NOTICE OF TENTATIVE DECISION

FILES: CU-04-16 and RL-01-16

TYPE OF APPLICATION: Conditional Use Review (Type II application) for expansion of an existing church and parking lot, together with a Tentative Replat to combined five existing lots into one lot.

EVANGEL ASSEMBLY
SITE IMPROVEMENT PLAN
FISHER CONSTRUCTION SERVICES, INC.
2815 SE PINE STREET, ALBANY, OREGON

C2.0

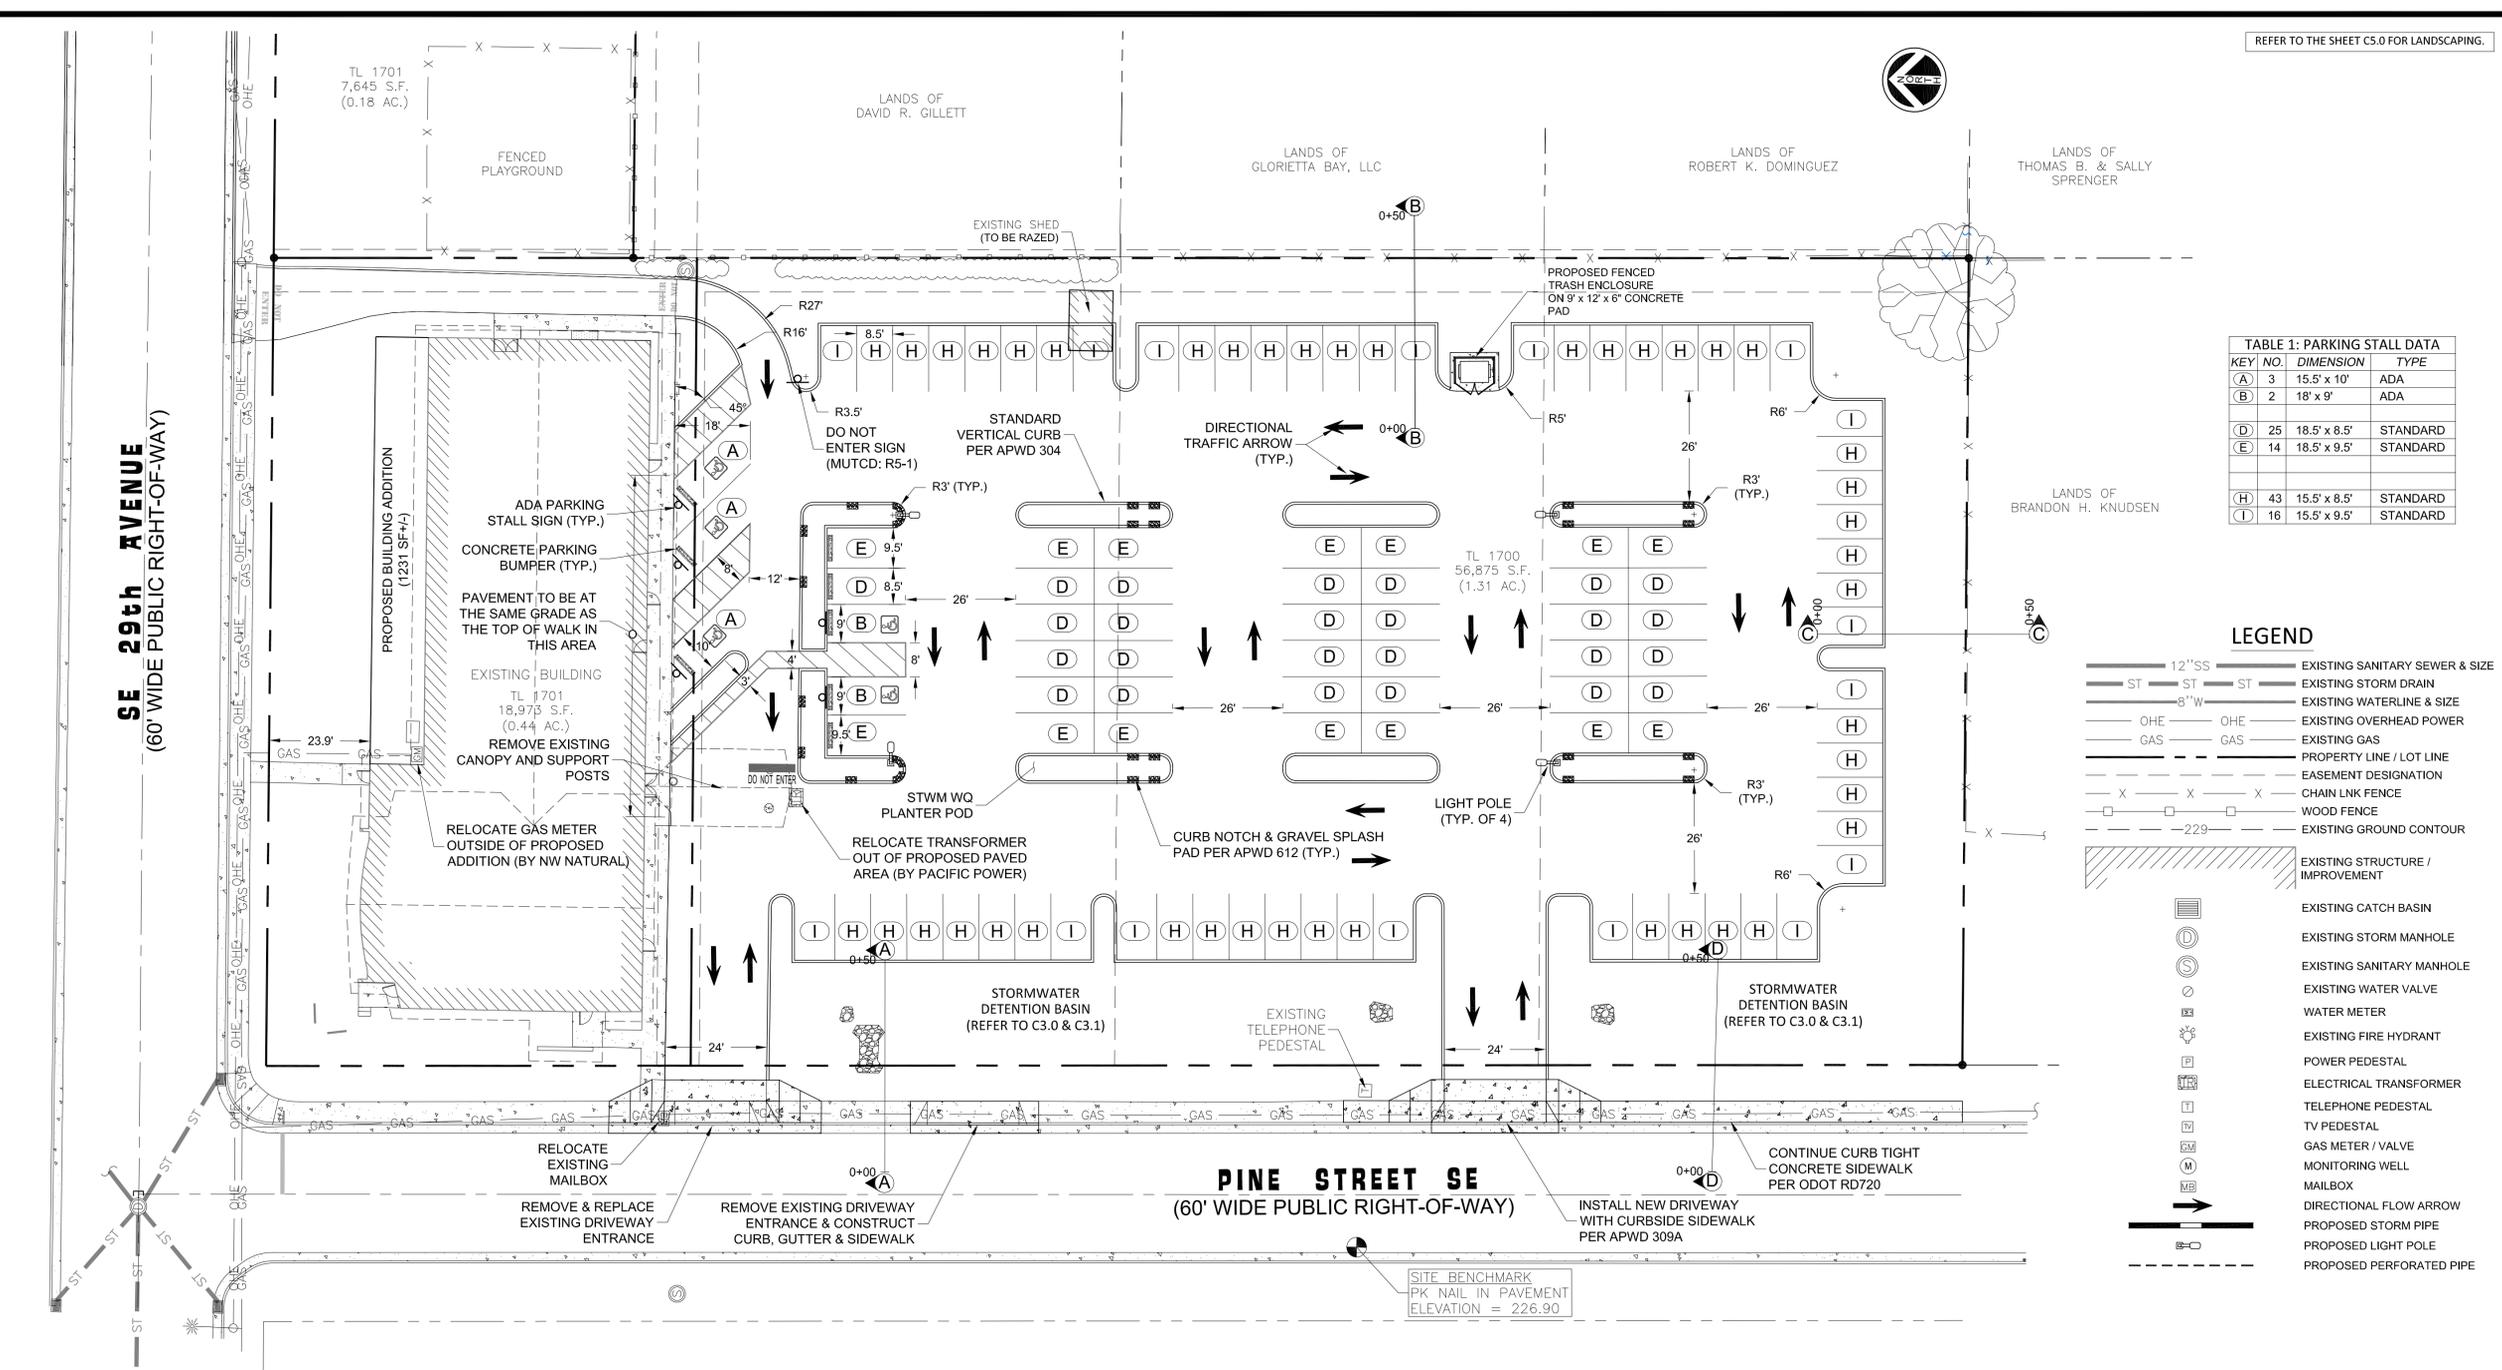
- 2.2 A total of seven bicycle parking spaces are required, four of which must be covered. A revised detail drawing showing the location of the bicycle parking spaces, at least half covered, all meeting required clearance standards, shall be submitted to the Planning Division for review and approval prior to issuance of a building permit. All required bicycle parking must be installed prior to occupancy.

- 2.3 In accordance with ADC 3.390, the refuse disposal area must be screened from view by placement of a sight-obscuring fence, wall, or hedge at least six feet in height. The applicant shall provide the method of screening that will be used on a detail drawing or on a revised site plan prior to building permit issuance and installed prior to occupancy.

- 2.4 Prior to issuance of a building permit, a revised landscape plan showing compliance with front setback, parking lot, and buffer and screening standards will be required for review and approval by the Planning Division. Nine additional one-gallon shrubs or accent plants will be required within the front setback area abutting 28th Avenue: 2 trees at least 6 feet tall, 8 one-gallon shrubs or accent plants, and attractive ground cover will be required along the church's Pine Street frontage; a minimum of five trees at least six feet tall, twenty one-gallon shrubs or accent plants, and attractive ground cover will be required along the parking lot frontage abutting Pine Street.

- 2.7 Prior to issuance of a building permit, the applicant shall revise building plans for the new addition to the church in order to meet the required 25-foot front yard setback or receive an approved Adjustment permit to reduce the required front setback to 23.75 feet.
